PIT5742A SES MIL / No Start / No Crank / Runs Rough / Reduced Engine Power / Loss Communication / DTCs (V8 and V6 Inspect Engine Harness)

Product Investigation Review Required

Models

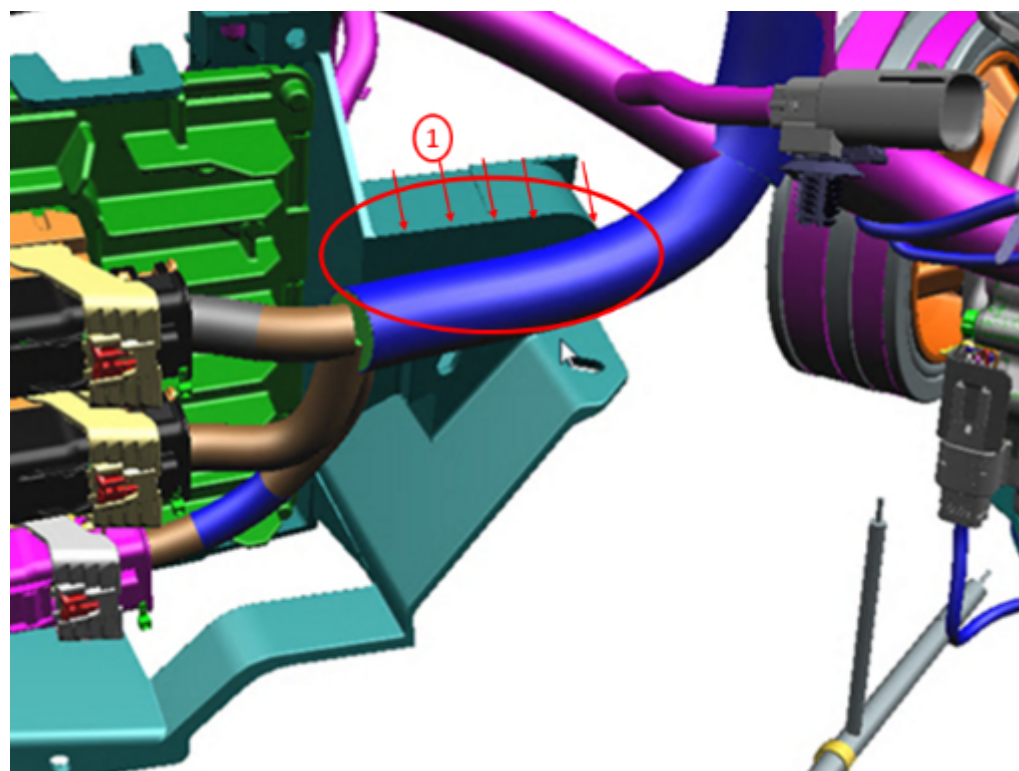
Involved Region or Country	North America
Condition	<p>Some customers may comment on any of the following concerns:</p> <ul style="list-style-type: none"><li>- SES MIL</li><li>- No Start</li><li>- No Crank</li><li>- Engine runs rough</li><li>- Reduced engine power</li><li>- Erratic gauge operation</li><li>- Transmission shifting erratically or not shifting</li><li>- Blown Fuse(s): F46UA, F78UA, F86UA, F88UA, F87UA, F90UA, F60UA, F67UA, and/or F91UA</li></ul> <p>When checking for DTC's there may be any of the following:</p> <p>P0101 P0103 P0106 P0108 P0300 P0562 P0615 P0617 P0641 P0689 P0700 P12A6 P15A0 P216E P1682 P16BD P16BC P2147 P06A3 P349P P2B96 U0073 U0078 U0100 u0101 U0102 u0121 u0128 U0129 u0131 U0140 U0146 U0184 U0422 U1345 U1346 U1347 U1348 U1349 U1501 U1502 U1503 U1510 U1511 U01B0 U18B4 U18D5 U2413</p>
Cause	<p>These concerns could be caused by the engine wiring harness chaffing on the ECM mounting bracket, as shown below. The ECM mounting bracket has a sharp edge (1) and it can cut into the wiring harness. Due to the number of circuits in the harness, there is a wide variety of different symptoms that could occur depending on which circuit(s) are damaged.</p>

Inspect the engine harness in the area shown above. If harness damage is found, repair the damaged wiring following the SI wire to wire repair procedures. Once repaired, protect the engine wiring harness using Woven Polyester (PET) Electrical/Anti-Abrasive Tape. This tape may be purchased at [kent-automotive.com](http://kent-automotive.com) Item# 1089482.
